Watercourse Pre-Determination Response

Further to receiving the response from the LLFA in relation to the planning application 144899/FO/2026 we would confirm that the culvert was surveyed using CCTV.

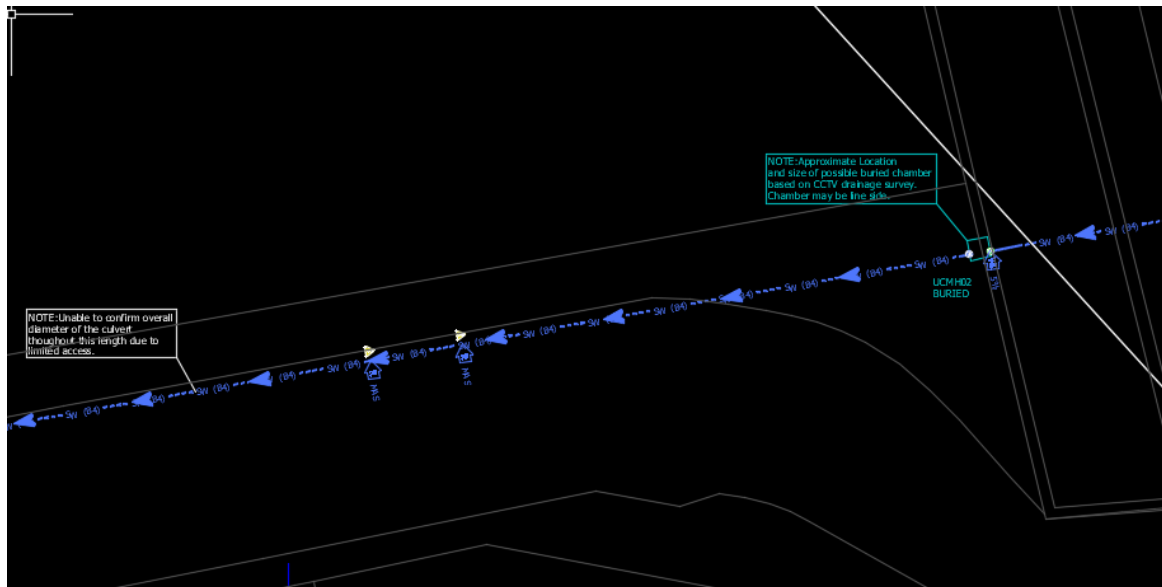
The survey of the culvert was carried out from UCMH02 upstream, as per below extract.

MH covers UCMH02 and UCMH03 could not be located on site.

A sond trace was used to locate the line of the culvert but due to the nature of the overlying material the received signal at ground level could not be confirmed. The signal to ground was being interfered with by material within the overlying soils.
